MODIFICATION SHEET NO. RDSO/2014/EL/MS/0431 Rev '0' Dated: 05.02.2014

Modification in loco control circuit for working of VEAD valve in trailing locomotive during multiple unit operation (MU) for 25 kV ac Electric Locomotive fitted with microprocessor based control and fault diagnostic system (MPCS ver-2)

Annexure-A

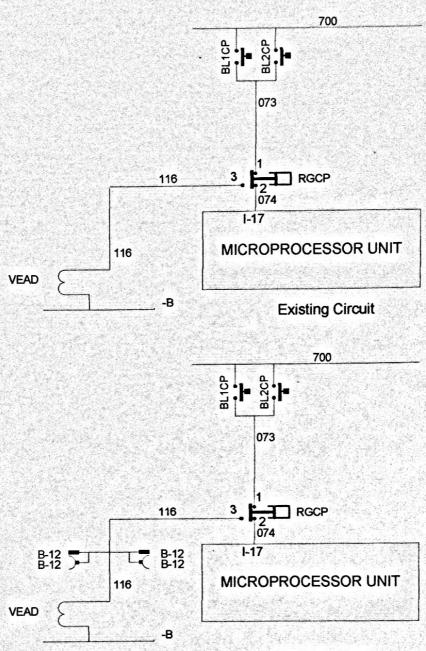
In MPCS locomotive Control circuit no. CLW.3W.15000.004 sheet no. 10 of 21, there is no extension of power supply for control of VEAD valve in the leading to locomotive to the VEAD valve of trailing locomotive. This means working of VEAD valves in two locomotives in MU operation is independent, i.e. there is no control of VEAD valve in the trailing locomotive from the RGCP of the leading locomotive. This results in accumulation of water in reservoirs of trailing locomotive.

SR advised to resolve this problem by adding a MU jumper for VEAD valve in MPCS ver-2 fitted locomotives.

One B-12 wire of MU coupler shall be connected to wire no. 116 for VEAD valve which is directly connected with RGCP pressure switch pin no. 3. as per Annexure A.

Wiring shall be done layout as per enclosed circuit in Annexure A.
